ADDENDUM TO APPLICATION
BLOCK 13, LOT 15 (9 CIRCLE DRIVE)
STEPHEN & NADIA HARHEN
BOROUGH OF RUMSON

Denial Memorandum

Date: December 4, 2024
Applicant: Stephen & Nadia Harhen / Robert W. Adler & Assoc.

Address: 9 Circle Drive Block Lot Zone
Rumson, NJ 07760 13 15 R-3

DRAWING:
COVERPAGE

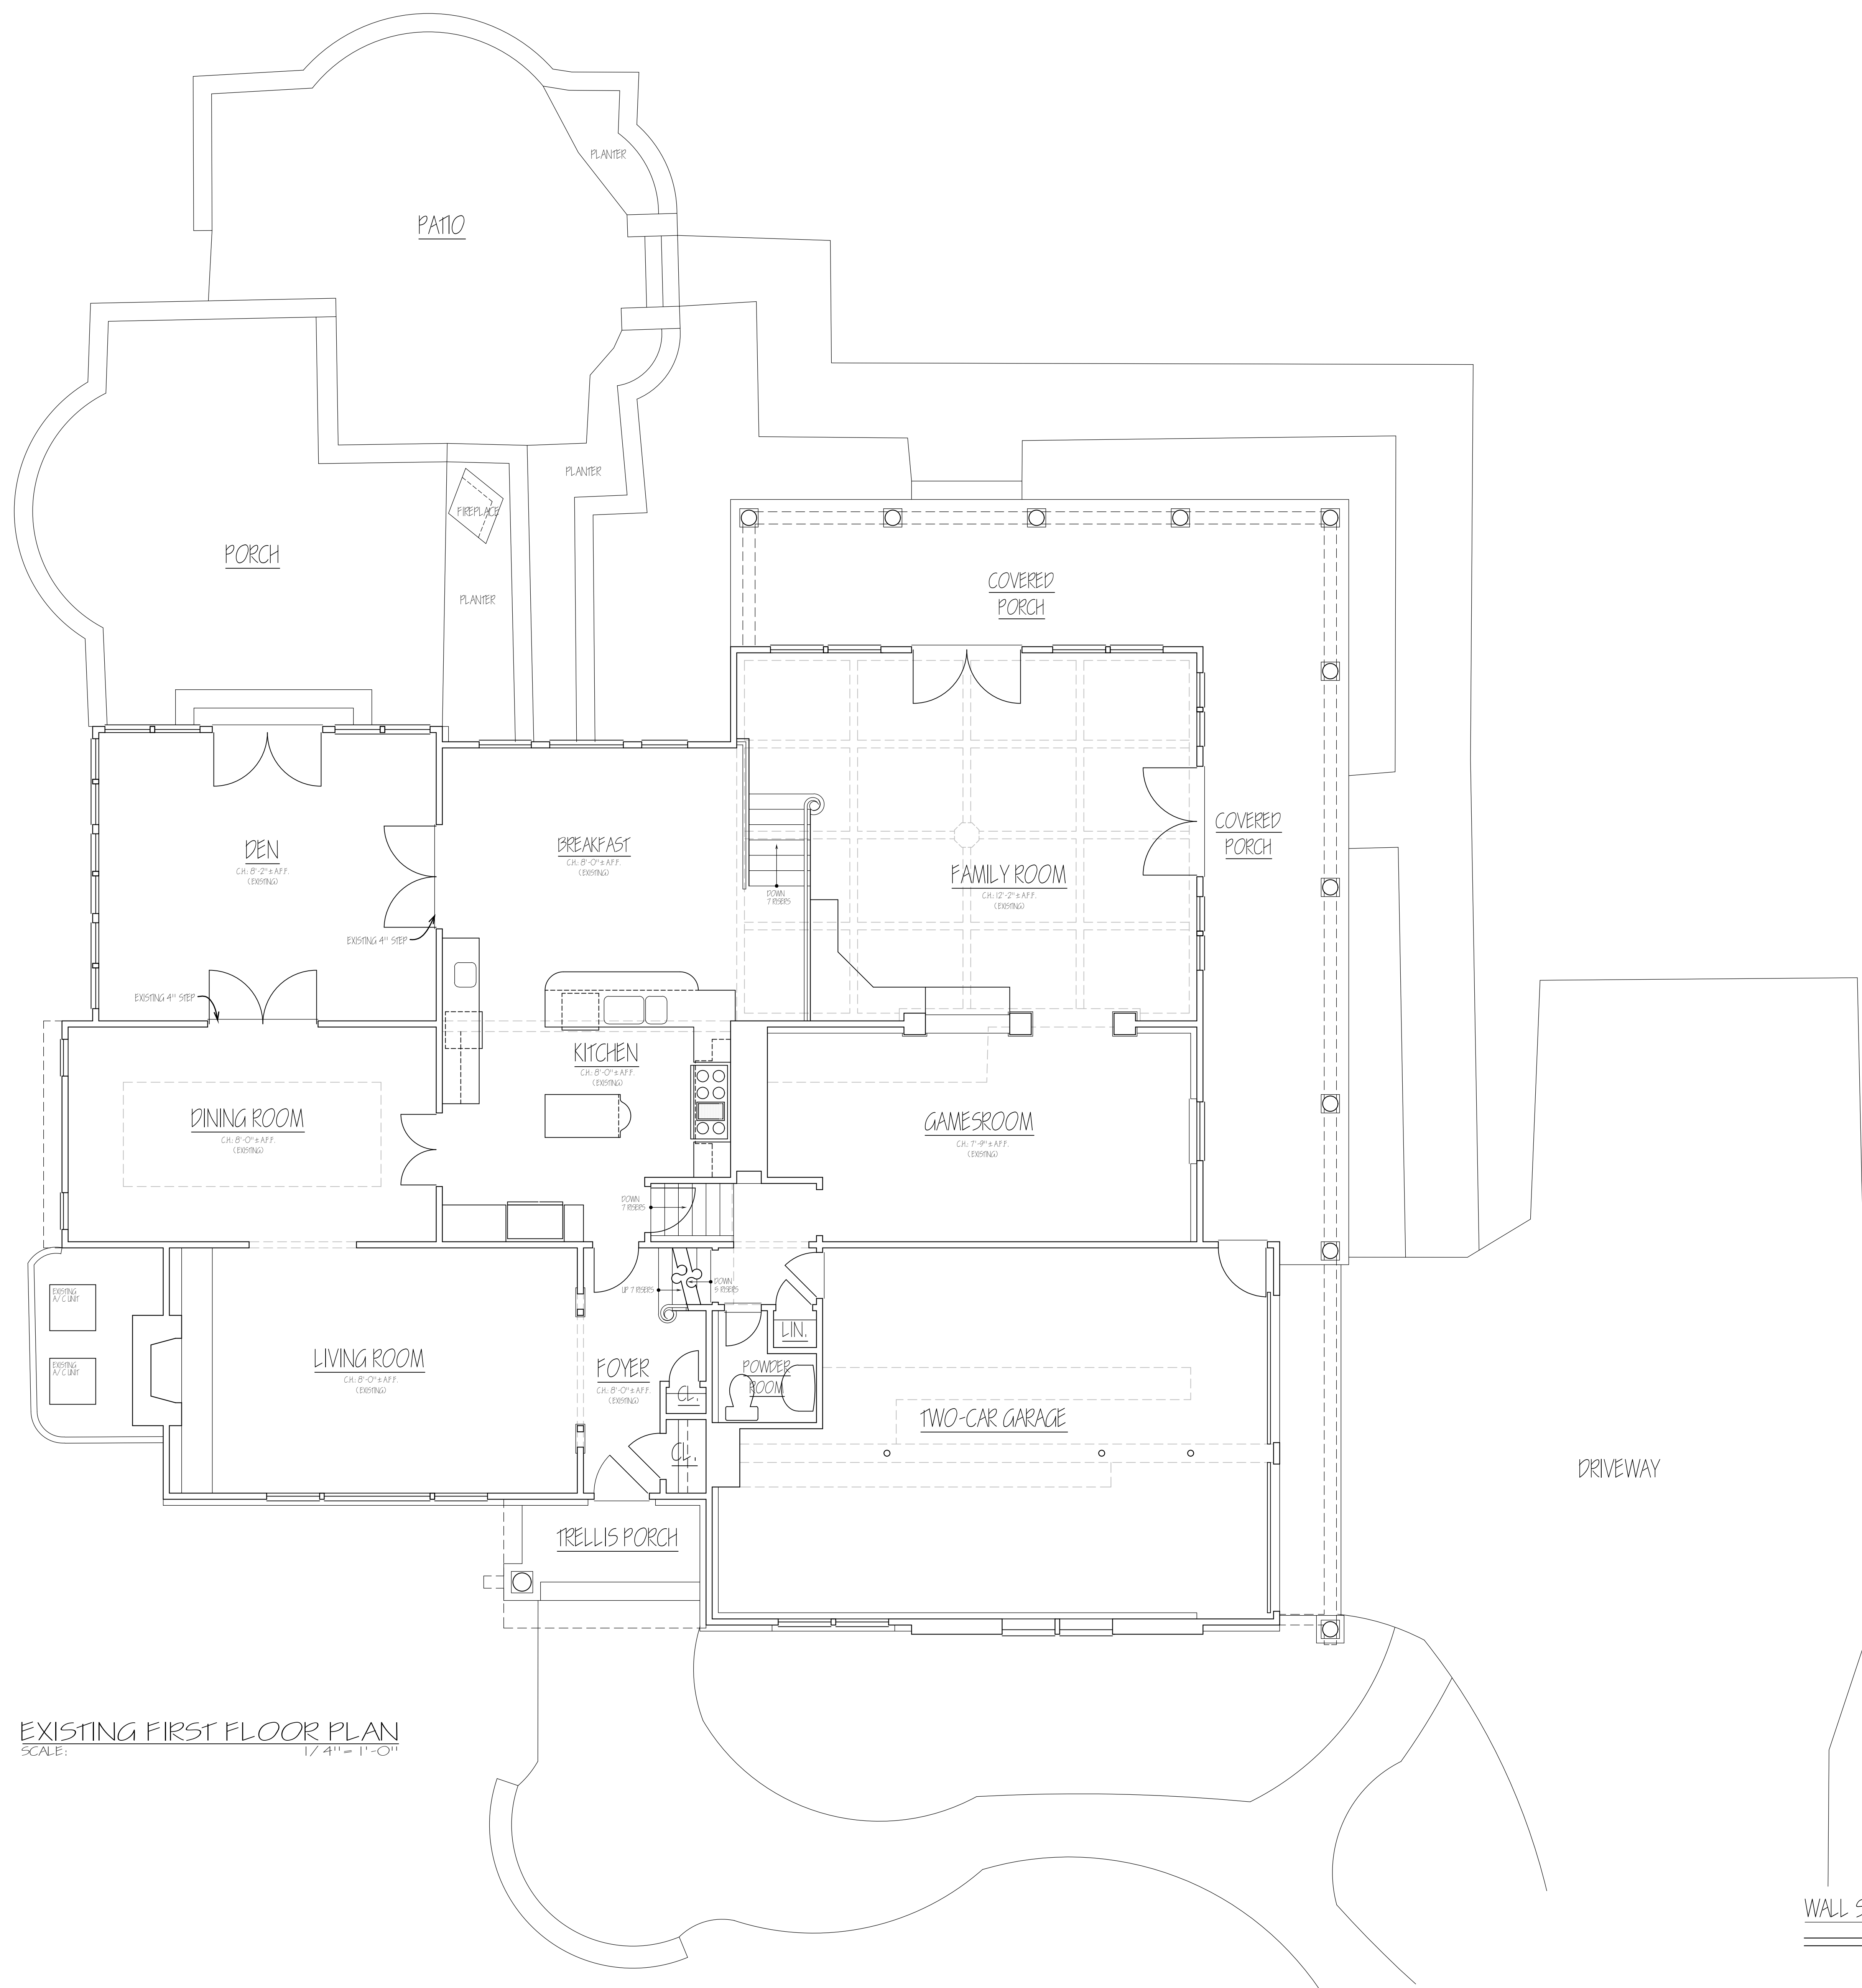
- A proposed Site Plan was not included with the application.
6. Zoning Chart Information requiring correction:
 - Required side yard setbacks of 22' / 42'

- Label of Proposed Calculations, sheet1 of 8
